South Texas Project
Units 3 and 4
Docket Nos. 52-012 and 52-013
Supplemental Response to Request for Additional Information

RAI 03.07.01-27, Supplement 1

RAI 03.07.01-27, Supplement 1**QUESTION:****Follow-up Question to RAI 03.07.01-19 (STP-NRC-100093)**

Revisions to COLA Section 3H.6

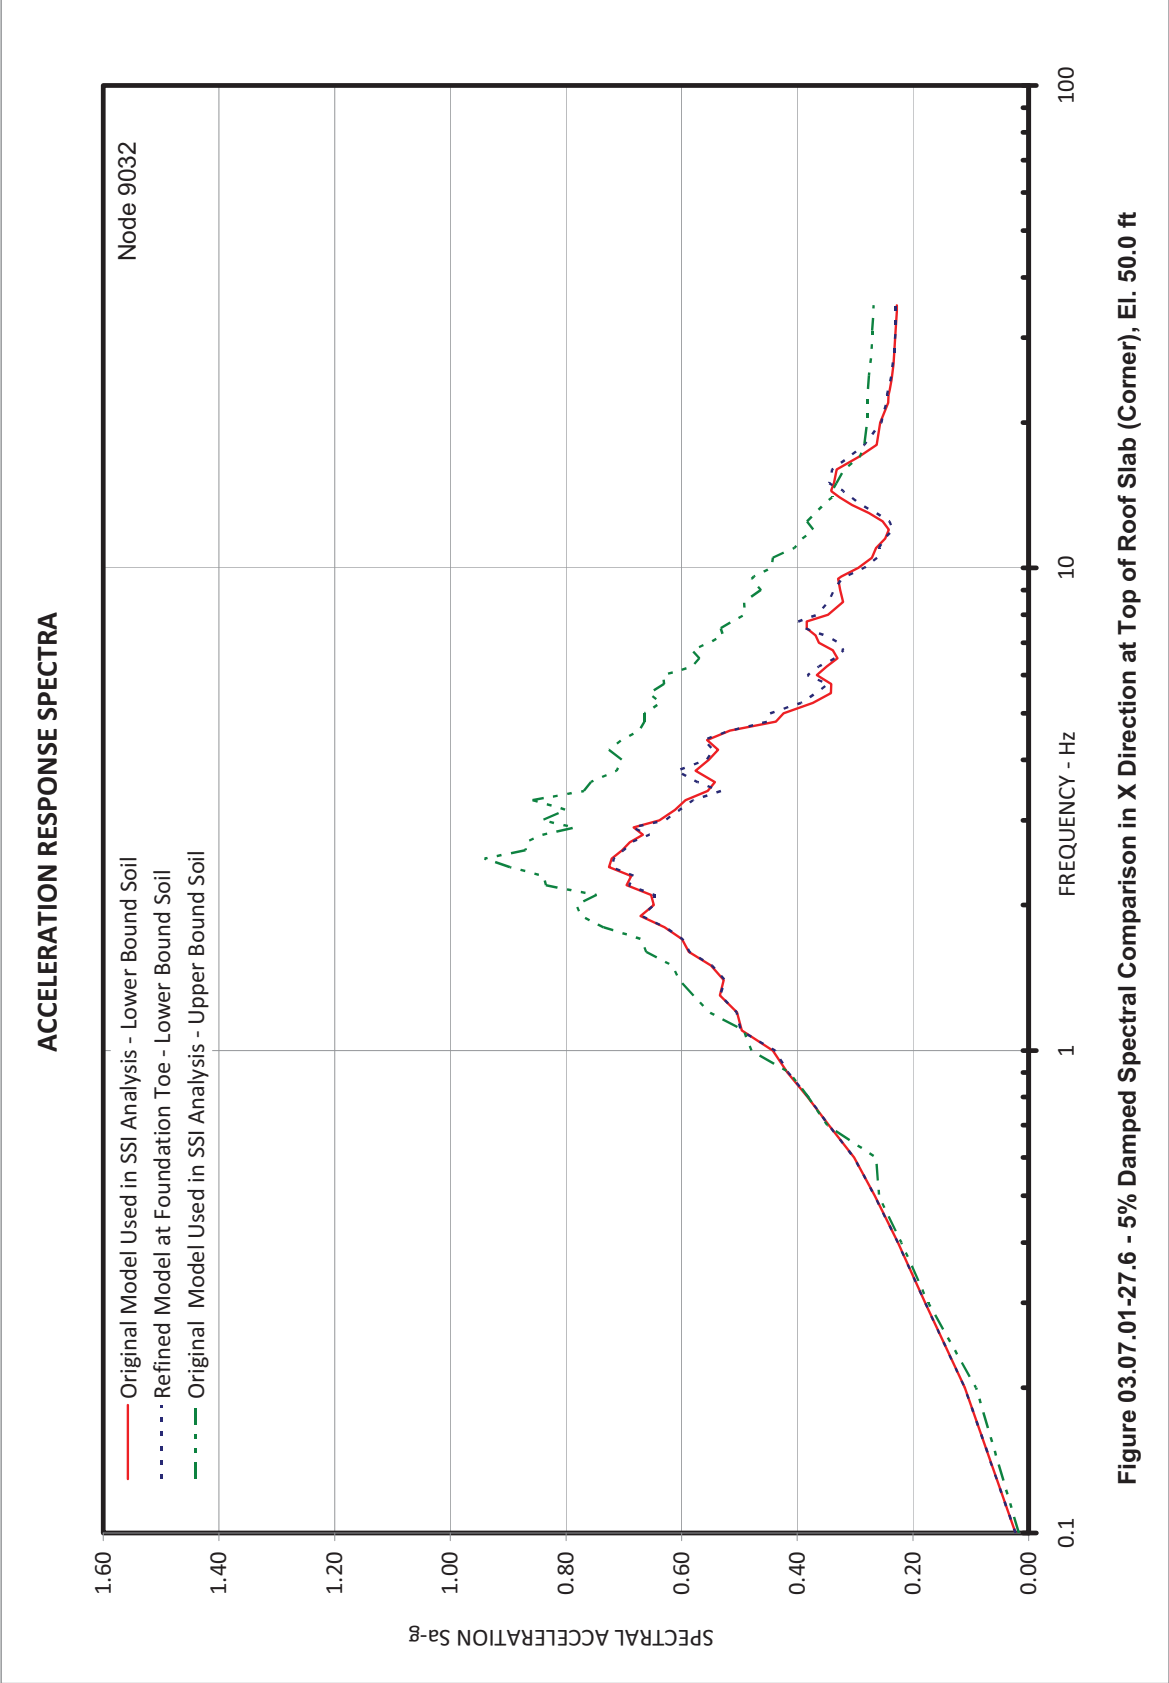
- (a) Describe in detail the method used for the SSI analysis of DGFOVS including the procedures for treatment of strain dependent backfill material properties in the model, input motion used and how it is specified in the analysis, variation of soil properties, and the computer programs used for SSI analysis.

To evaluate the effect of 20 Hz passing frequency for LB in-situ case, the foundation toe was divided into two elements, thus increasing the passing frequency to 40 Hz. This refined model with LB in-situ soil properties was analyzed and 5% damped spectra from this model were compared with the spectra from the original model with passing frequency of 20 Hz. The spectra comparison plots are shown in Figures 03.07.01-27.1 through 03.07.01-27.24. The comparison shows that:

- In the X direction, there is insignificant difference between the response spectra from the two models
- In the Y direction, the response spectra from the two models matched well except at frequency of about 3.8 Hz where the refined model produced higher spectra. However, spectra from both the models are enveloped by the spectra for UB in-situ soil case
- In the vertical direction, the spectra from the two models matched well (insignificant difference)

Based on the above evaluation it is concluded that the horizontal direction passing frequencies are acceptable.

Figure 03.07.01-27.25: Comparison of Horizontal Response Spectra at DGFOSV 1A Basemat Top

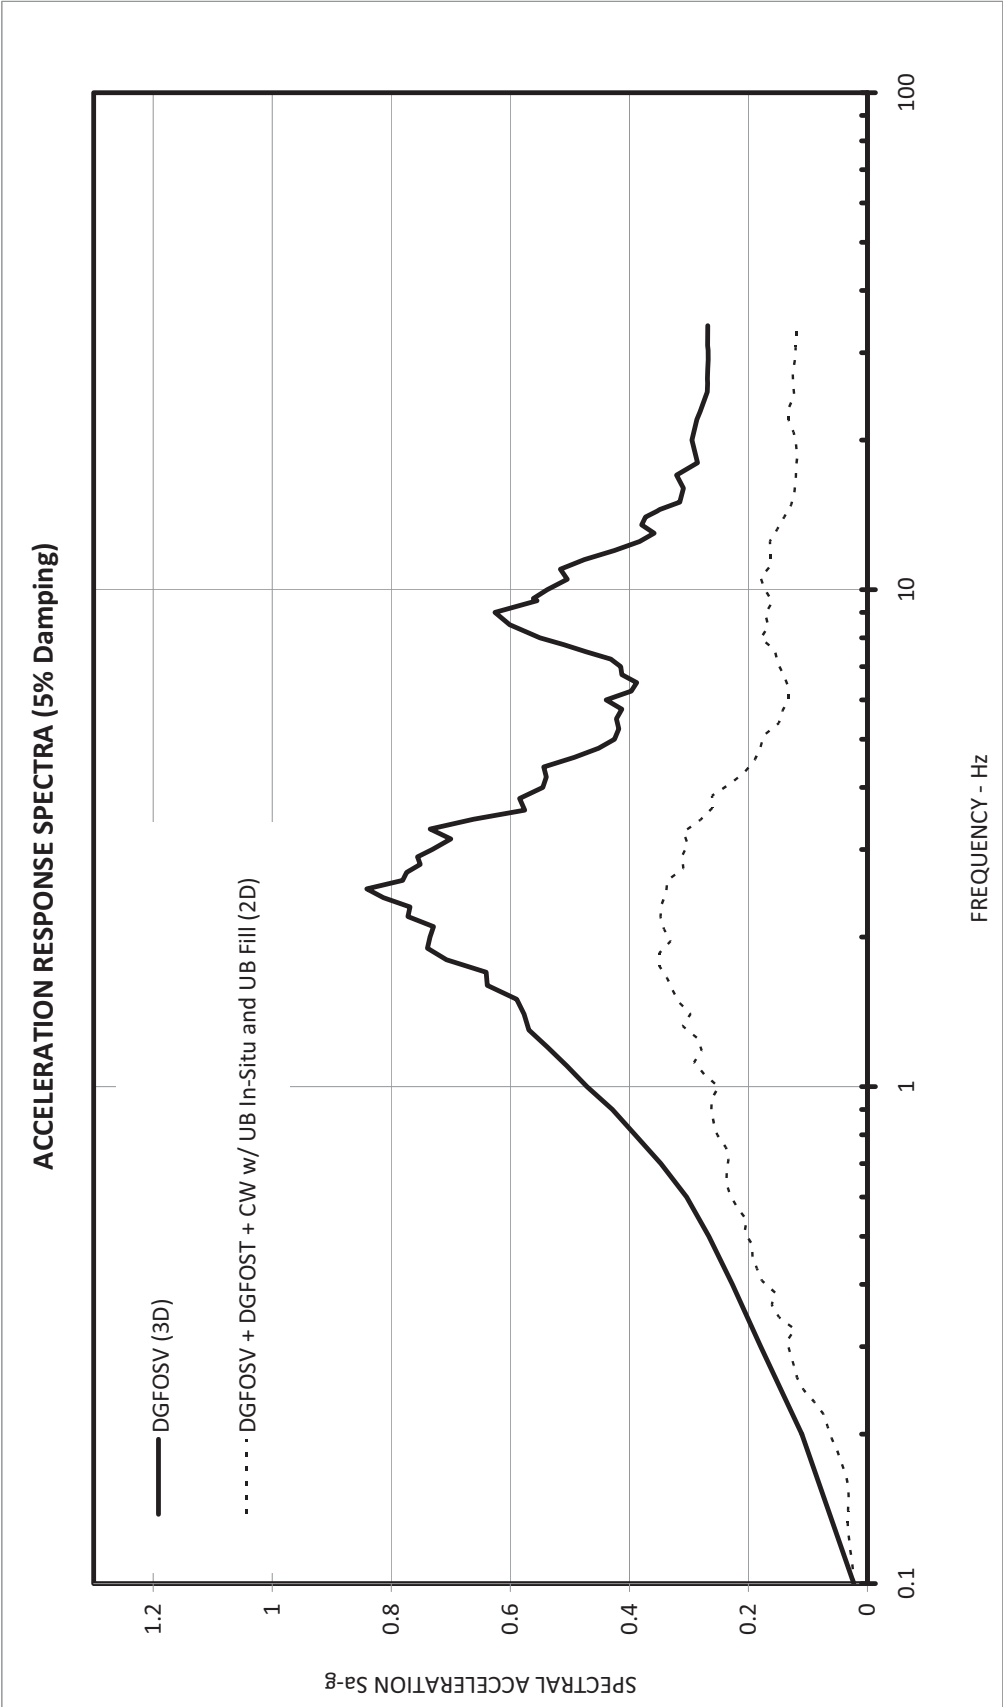
- (c) Demonstrate that the DGFOVS foundation response spectra and dynamic soil pressure (on DGFOVS basement walls using ASCE 4-98 criteria) used in the design of DGFOVS will envelop the results of structure to structure (SSSI) interaction analysis which explicitly models DGFOVS structure in the SSI model of RB and the RSW Pump House structure.

Figures 03.07.01-27.25, 03.07.01-27.26 and 03.07.01-27.27 show the comparisons between the DGFOVS foundation level 5% damped response spectra obtained from the

3D SSI analysis (enveloped for all soil cases and used for the design of the DGFOVS) and the 5% damped foundation spectra obtained from 2D SSSI analyses. The comparisons show that the design spectra obtained from the 3D SSI analyses envelop the spectra obtained from the 2D SSSI analyses. Note that the input motion for the 3D SSI analysis corresponds to 0.3g Regulatory Guide 1.60 spectra, and the input motion for 2D SSSI analysis is the site specific SSE.
